Access Compliance Report

Public Rights-of-Way

Intersection ID: 46734	Main Street: BOBHOUSE_DR	Cross Street: THREATT_WOODS_DR	Location: SE
ADA ID: F8C83DF1C828	Ramp Type: PerpDiag	Initial Pass/Fail: Fail	Overall Compliance: No
Severity Score: 8.75			
Codes/Mitigation Info/Possible Solution		Field Measurements/Component Compliance

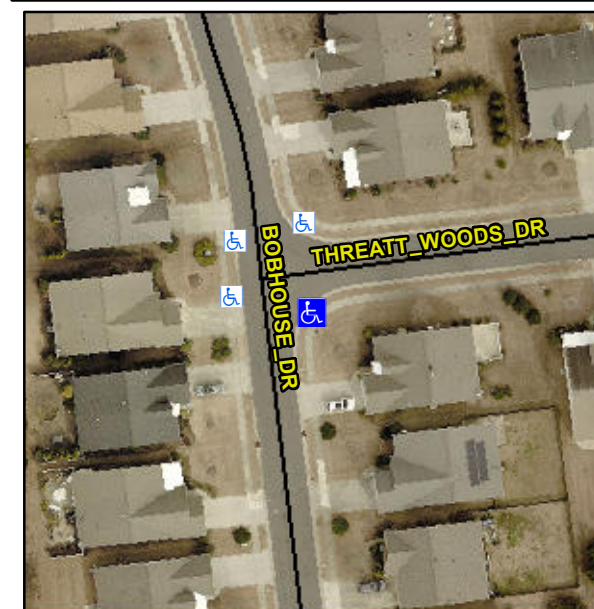
Not Found, R304.5.1

Compliance	Description	Data	Compliance	Description	Data
N/A	Ramp Length (in)	48.0	Yes	Ramp Slope (%)	5.4
No	Ramp Width (in)	41.0	Yes	Ramp XSlope (%)	0.1
N/A	Flare Type LT	N/A	N/A	Flare Type RT	N/A
N/A	Flare Slope LT (%)	N/A	N/A	Flare Slope RT (%)	N/A
N/A	Flare Traversable LT?	N/A	N/A	Flare Traversable RT?	N/A
N/A	Landing Length (in)	N/A	N/A	DWS Provided?	N/A
N/A	Landing Width (in)	N/A	N/A	DWS Contrast?	N/A
N/A	Landing Slope (%)	N/A	N/A	DWS Length (in)	N/A
N/A	Landing X Slope (%)	N/A	N/A	DWS Full Width?	N/A
N/A	Landing Curb? (Y/N)	N/A	N/A	DWS Offset (in)	N/A
N/A	Shared Landing?	N/A			
N/A	Gutter Ponding?	N/A	N/A	Gutter Slope (%)	N/A
N/A	Gutter Lip Ht (in)	N/A	N/A	Gutter X Slope (%)	N/A
N/A	Painted X Walk1?	No	N/A	Painted X Walk2?	No
	X Walk 1 Direction	To NE		X Walk 2 Direction	To NW
N/A	X Walk 1 Width (in)	N/A	N/A	X Walk 2 Width (in)	N/A
	X Walk 1 Slope (%)	3.8		X Walk 2 Slope (%)	2.3
	X Walk 1 X Slope (%)	1.0		X Walk 2 X Slope (%)	3.1

Remove & Replace Curb Ramp With Two New Directional Ramps or Equivalent.
